PUBLIC HEARING MEMORANDUM

SUBJECT: **Petition #23-18**, for SPECIAL PERMIT/SITE PLAN APPROVAL to allow a three-unit multi-family dwelling, allow a garage in excess of 700 square feet, allow parking in the front setback, allow a driveway width in excess of 20 feet, and allow a retaining wall of greater than four feet in the setback at **19-21 Orchard Street**, Ward 1, Newton Corner, on land known as SBL 71, 16, 1, containing approximately 12,320 sq. ft. of land in a district zoned MULTI RESIDENCE 2. Ref: §3.4.1, §3.4.2.C.1, §5.1.7, §5.1.7.A, §5.4.2.B, §5.1.13, and §7.3.3 of the City of Newton Rev Zoning Ord, 2015.

19-21 Orchard Street

ZONING REVIEW MEMORANDUM

View from Orchard Street

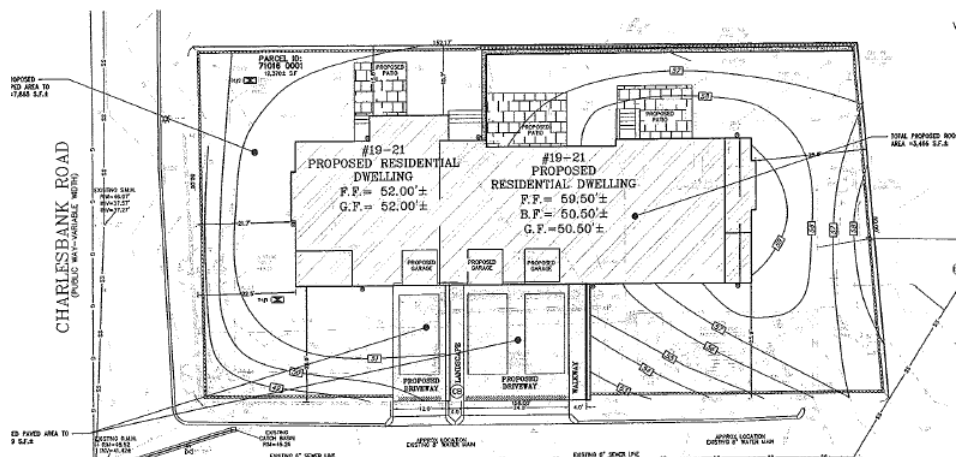
The Planning Department is generally not concerned with the multi-family structure as proposed given the multi-family character and density of the neighborhood. Staff believes the design utilizes features such as dormers and a front porch to add interest to the facades and reflect the context of the neighborhood. Additionally, staff believes the petitioner has sited the structure to achieve a balance between open space and vehicular access, but believes further refinements can be made to the width of the curb cut along Orchard Street. Lastly, staff suggests the petitioner explore creating a pedestrian entrance from Charlesbank Road to the westernmost unit which may give the structure more of a presence from the street.
